SECOND GENERATION DISTRICT PLAN

Variation 2 – Additional Housing Capacity Part 3 – Sites Proposed for Rezoning

Evidence on Transport

SUBJECT: **VARIATION 2: TRANSPORT RESPONSE TO REQUEST FOR COMMENTS ON GREENFIELD REZONING SITES – REJECTED SITES**

RS110: 23 Sretlaw Place / 118 Brockville Road – Rezoning from Rural to General Residential 1

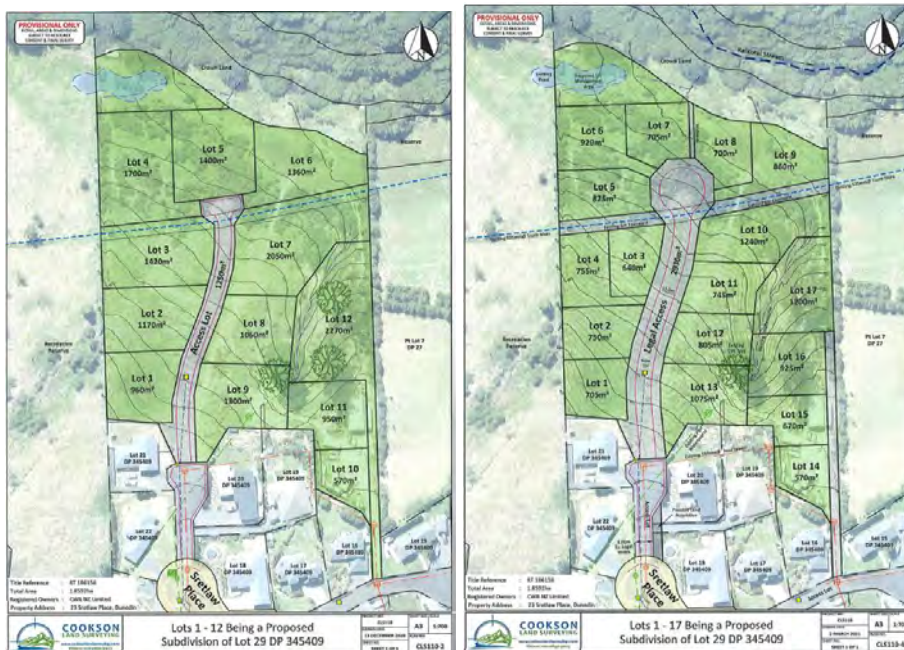
30. Plan CLS110-2 (left) shows 3 lots accessed over 18 Sretlaw Place and 9 lots accessed over 25 Sretlaw Place, both of which appear to be shared access lots.

31. Plan CLS110-4 (right) shows 4 new lots access over 18 Sretlaw Place and 13 new lots accessed over 25 Sretlaw Place, and hence, is essentially an up-scaled version of CLS110-2.

RS205: 761 Aramoana Road – Rezoning from Rural to Township and Settlement

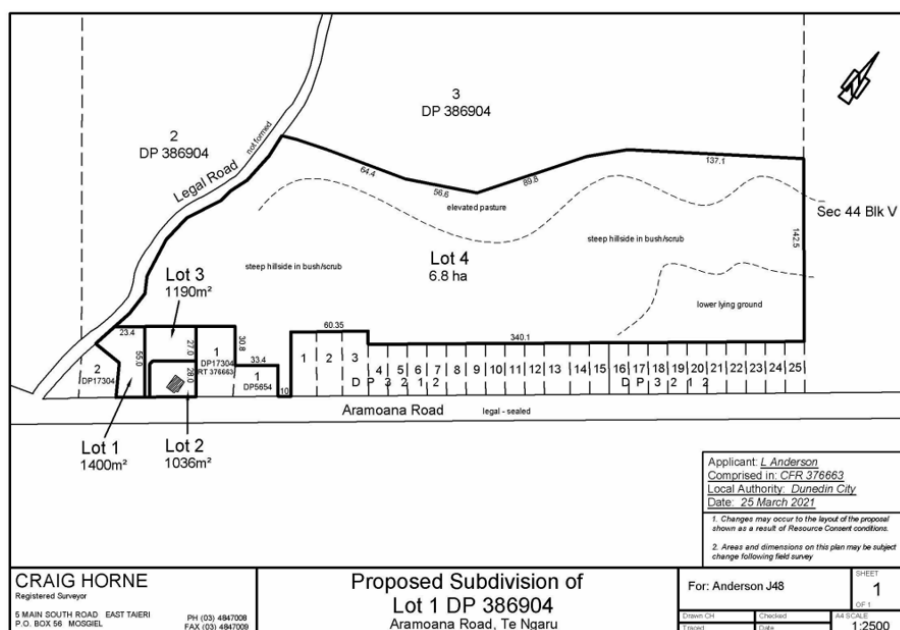
80. An additional 3 residential sites would have an insignificant impact on the transport network. Any existing issues with the transport network would not be exacerbated to any noticeable extent because the scale of development being considered is small.
81. That said, access to the new sites would need to be assessed by the developer at the time of subdivision and confirmed as complying with minimum sight distances requirements in the 2GP.

Figure 1 : Proposed Re-Zone Site Structure Plan

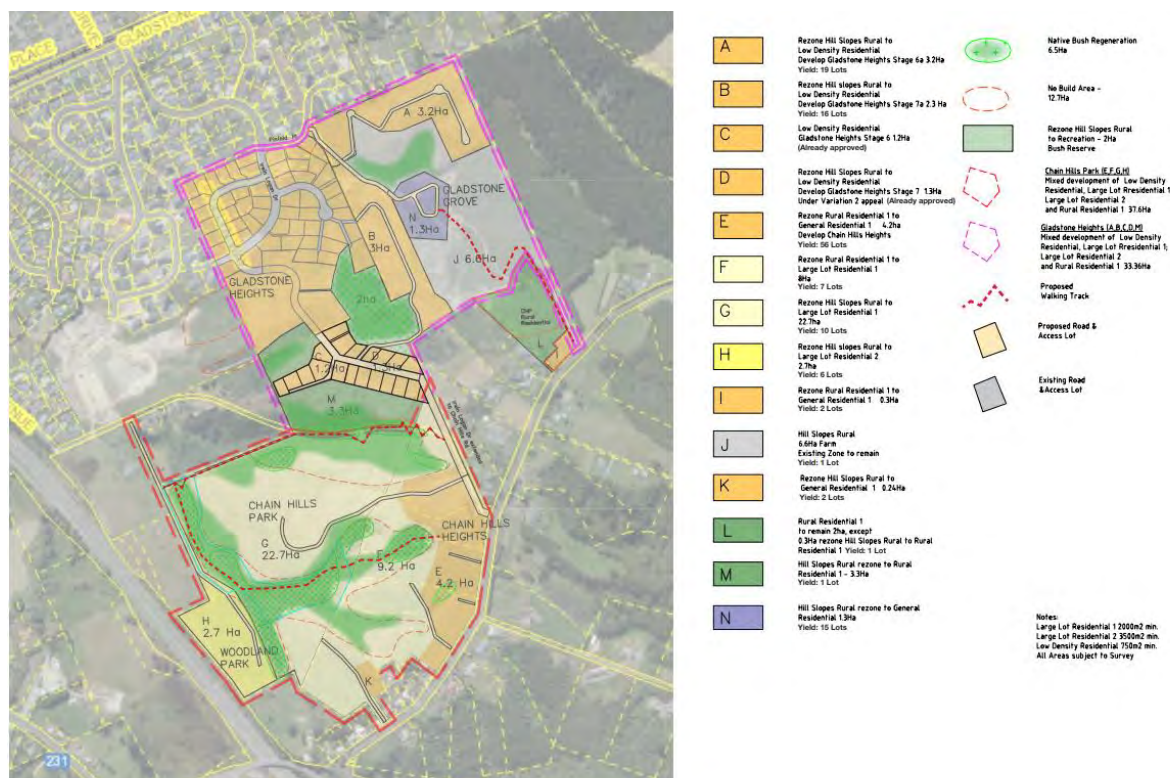
86. FS105 opposes the change and specifically notes that they oppose the proposed road connection from Gladstone Road North to Chain Hills Road due to safety concerns.

87. FS107, FS108, FS118, FS246, FS26, FS46, FS48 and FS165 oppose the change primarily due to concerns about the road connection. They consider that Chain Hills Road and Morris Road are currently unsuitable to accommodate the change. FS165 notes that there are no pedestrian or cycle facilities on Chain Hills Road and suggests that the developer should be required to construct a cycle and pedestrian path at least along the area where the proposed road will join Chain Hills Road and the junction with Morris Road, and provide for a dedicated cycle lane along Morris Road and possibly Main Road as far as the Old Brighton Road turnoff. They also consider it is questionable to promote cars leaving the motorway at Fairfield to reach Mosgiel because they would need to pass the Fairfield Primary School.

89. FS89 opposes the submission, but in particular opposes the road connection between Gladstone Road North and Chain Hills Road. They comment that the Irwin Logan Drive / Gladstone Road North intersection will 'become an increasing bottleneck'. They consider that this intersection would require a roundabout. They also raise concerns about more traffic turning right from Irwin Logan Drive into Heathfield Drive and associated effects on the safety and efficiency of Gladstone Road North.

98. It is noted that even if the concerns raised on Chain Hills Road with respect to inadequate facilities for non-motorised users are resolved, that the same issues exist on Morris Road. There are no current plans for Council to install footpaths or cycle facilities on Morris Road, and hence, the development is likely to increase pressure for Council to install this infrastructure. This would be a significant project in terms of scale and cost.

102. Overall, then, it is considered that in the absence of any detailed traffic/transport analysis, that Transport is currently unable to provide its support to the proposed rezoning.

Figure 1: Potential Structure Plan proposed by Submitters

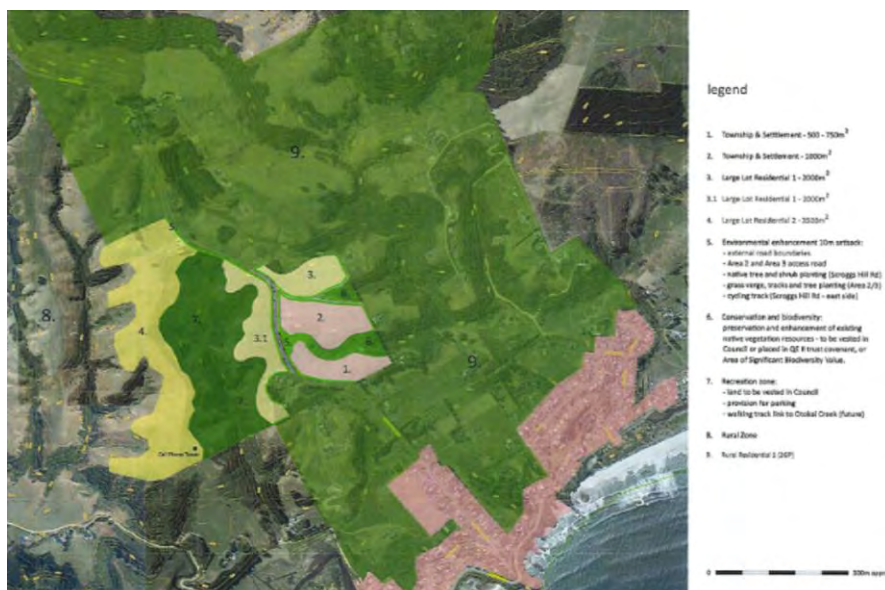
25. Hence, assuming the areas within the submitter's Structure Plan **AND** RS220 were rezoned, a combined yield in the order of 244-694 dwellings would be the result. If GF01 was rezoned also, the overall yields would be in the order of 289-739 dwellings.

28. In response to FS75.1 & FS75.2, capacity of a ROW is not something that would typically be considered as part of a rezoning proposal. The subdivision consent process provides the appropriate platform for these types of more detailed considerations.

29. In response to FS217.3 & FS217.4, it is noted that these concerns were noted by Transport in the assessment of the above GF01 site. These concerns would be amplified with the additional dwelling yields enabled by RS160 and RS220 (as described in Paragraph 20).
